Proposal # 29: 1198-03-74, WISC 2019 752
C Superior, East Second Street
2nd Avenue East To 31st Avenue East
USH 02
Douglas County

This is Addendum No. 02, which provides for the following:

ADDENDUM NO. 02

1198-03-74

Addendum No. 02
 ID 1198-03-74
 Revised Sheet 9
 December 5, 2019

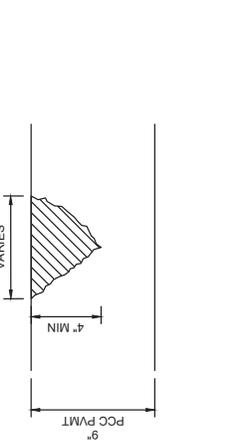
Revised Plan Sheets	
Plan Sheet	Plan Sheet Title (brief description of changes to sheet)
9	Concrete Pavement Centerline Joint Repair detail
405	Structure B-16-68 Design Data, Quantities And Notes- color req'd removed

NO. 6 TIE BARS EPOXY COATED, 12-INCH LONG (MINIMUM) ANCHORED INTO EXISTING PAVEMENT. MAXIMUM DRILLED HOLE SIZE IS 1/8-INCH GREATER THAN TIE BAR DIAMETER.

REMOVE ALL CONCRETE, ASPHALT, AND ANY UNSOUND MATERIAL FROM TRANSVERSE AND LONGITUDINAL AND RANDOM CRACKS. LOCATIONS WILL BE DETERMINED BY THE ENGINEER IN THE FIELD.
 ASPHALTIC SURFACE PATCHING SHALL BE PLACED IN THE JOINT REPAIR AREA. PATCHING SHALL BE COMPACTED IN LIFTS (2 LIFTS MINIMUM) UNTIL FLUSH WITH THE SURFACE OF THE CONCRETE. ASPHALTIC SURFACE PATCHING PAID SEPARATELY FROM THIS ITEM.
 DEPTH OF REPAIR SHALL BE A MINIMUM DEPTH OF 4 INCHES TO A FULL DEPTH JOINT AS CONDITIONS DICTATE.
